Ref: NHTSA Campaign Number 06V-306

Recall 06V-306

PROCEDURE TO REMEDY WIRING DEFECT

ABS MODULATOR VALVE JUMPER HARNESS INSTL

SHEET 1 OF 2

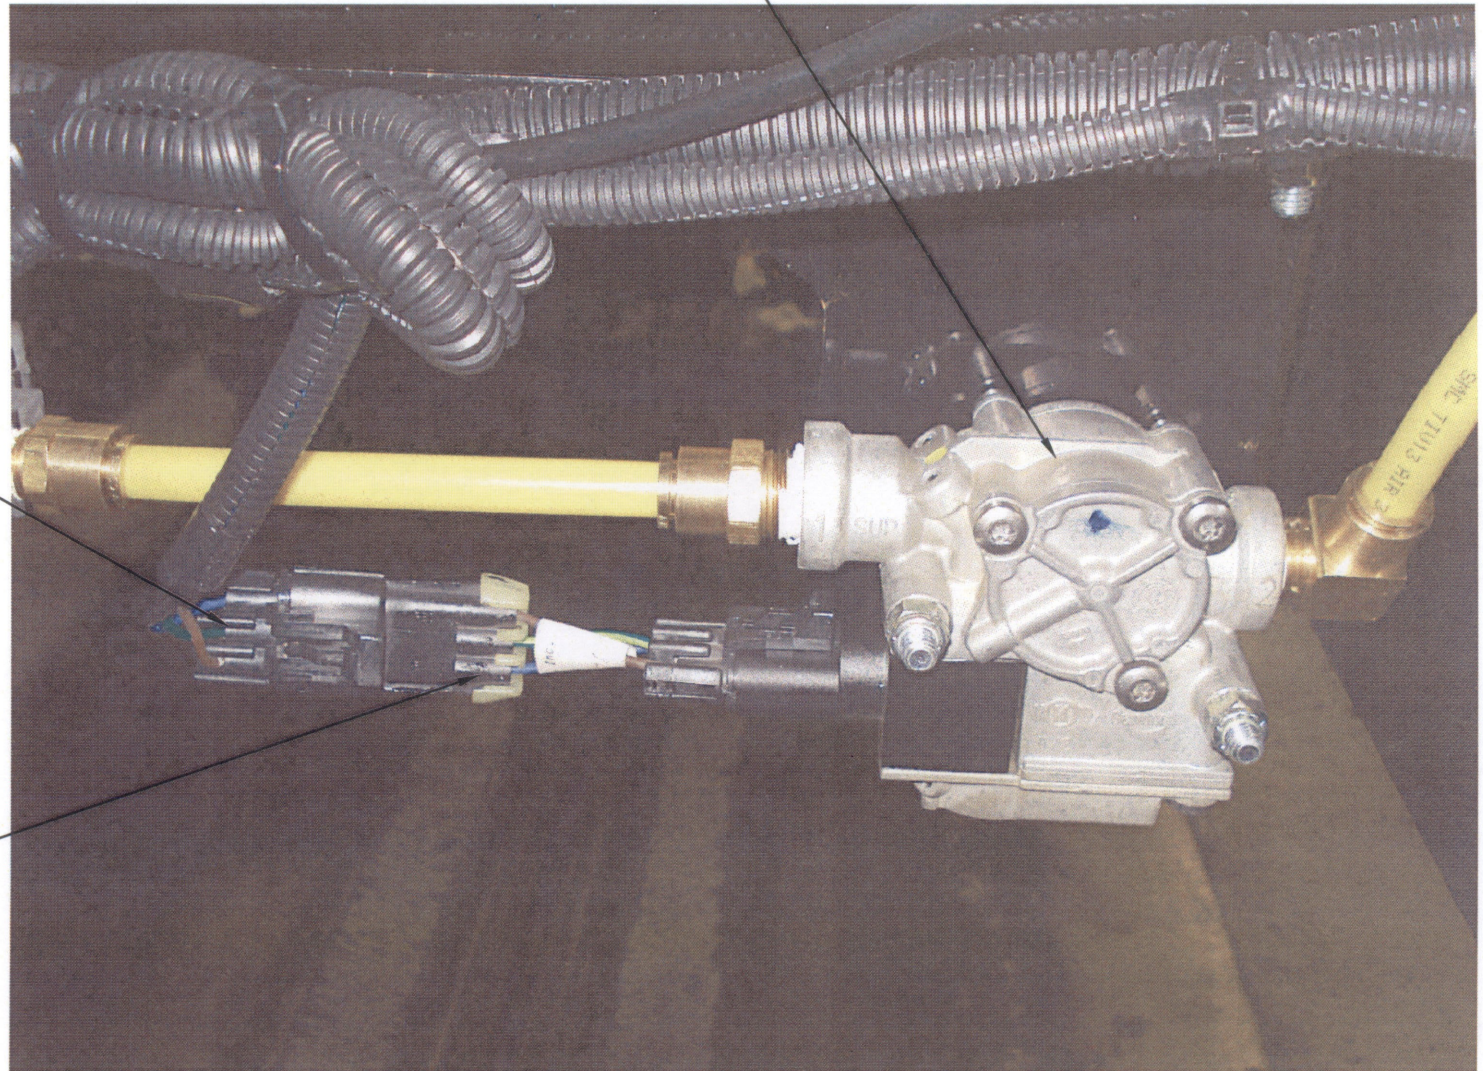
The defect is in the Anti-lock Brake System ("ABS"). The electrical wiring to the ABS modulator valves from the electronic control module ("ECM") is incorrect. The wires to the "Exhaust" and "Hold" connections on the ABS Modulator valves are reversed. In an anti-lock braking event this will cause the anti-lock braking system to malfunction. The anti-lock brake system performance will be degraded.

(please see installation information- Sheet 1, attached)

1. Locate the ABS modulator valves for both the front and rear axles.
2. The two (2) front valves (Bendix Model M-30 or M-32) are visible behind the cab deck grill opening at the front of the truck. They are mounted just under the front frame cross member. Locate and remove the three (3) wire connectors on the main wiring harness from each of the valves. This connector may only be removed by releasing the locking latch on the connector. This is done by lifting the latch bar to open the lock and pulling on the connector at the same time. A small screwdriver may be used for ease in opening the latch bar. Install the Modulator Valve Jumper harness connector by inserting it into the connector on the modulator valve body and firmly pressing until the connector stops and latches. Install the original wiring harness connector into the other end of the modulator valve jumper harness connector, pressing firmly until the connector stops and latches.

CAUTION: ENSURE THAT THE WIRING HARNESS CONNECTOR THAT WAS REMOVED FROM THE VALVE IS INSTALLED IN ITS ORIGINAL VALVE POSITION

INSTALL MODULATOR VALVE JUMPER HARNESS 53562728 BETWEEN ABS CHASSIS HARNESS AND EACH MODULATOR VALVE

SHEET 2 OF 2

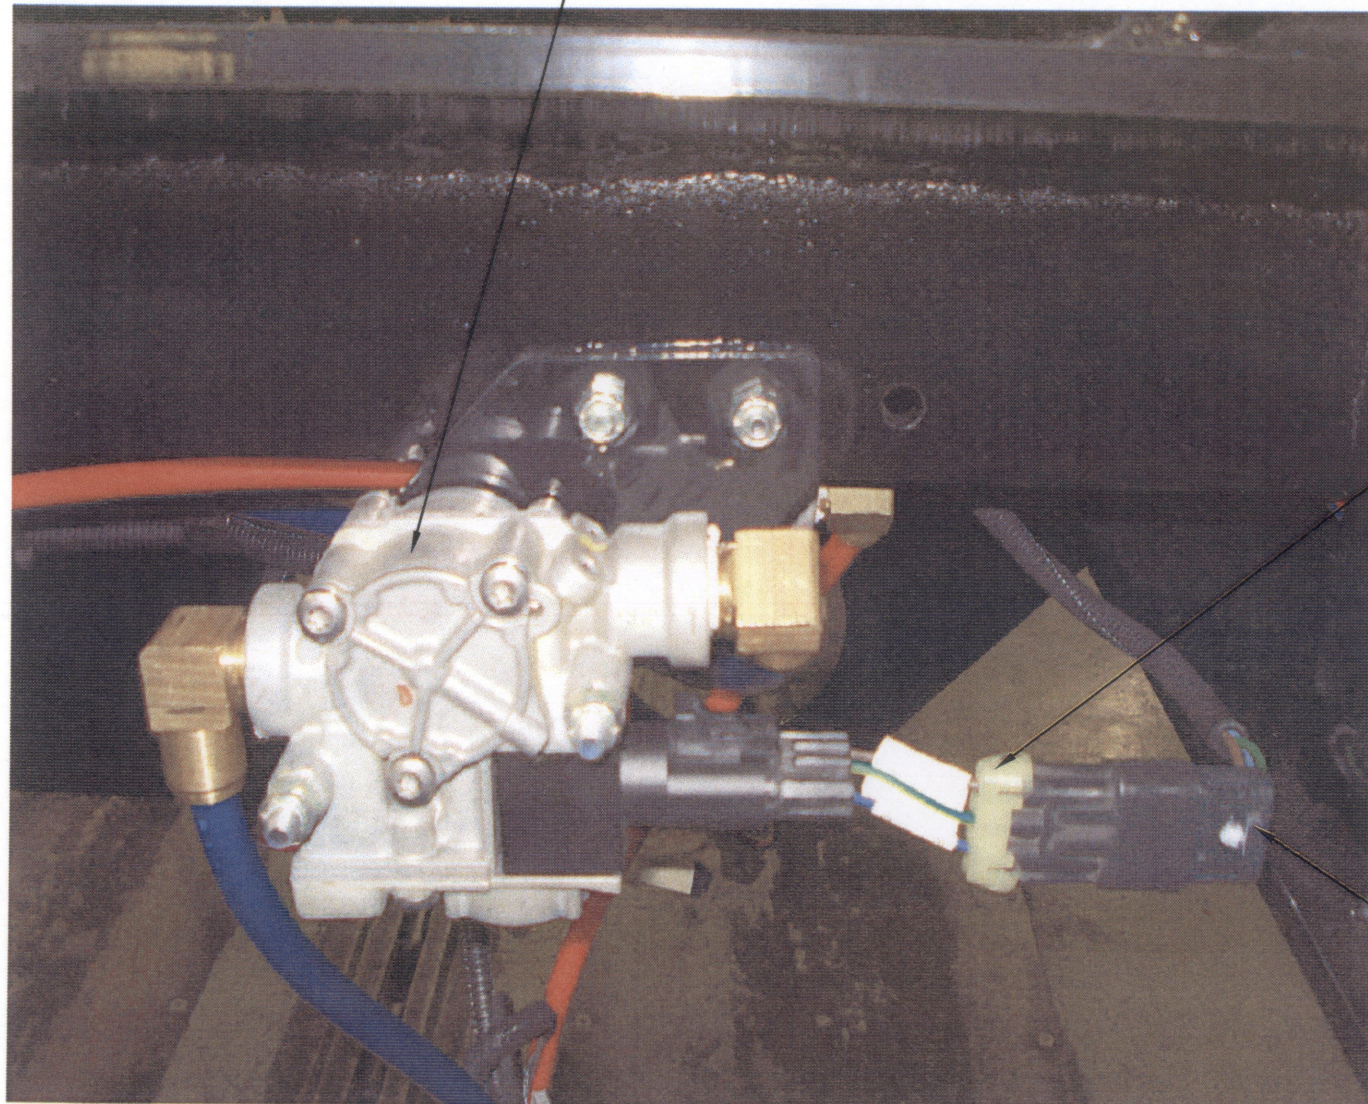
3. The two (2) rear valves (Bendix Model M-30 or M-32) are located under the rear frame cross member and are only visible from beneath the truck. Locate and install the modulator valve jumper harnesses procedure as for the front. (please see installation information, Sheet 2, attached)

CAUTION: ENSURE THAT WIRING HARNESS CONNECTOR THAT WAS REMOVED FROM THE VALVE IS INSTALLED IN ITS ORIGINAL VALVE POSITION

INSTALL MODULATOR VALVE JUMPER HARNESS 53562728 BETWEEN ABS CHASSIS HARNESS AND EACH MODULATOR VALVE
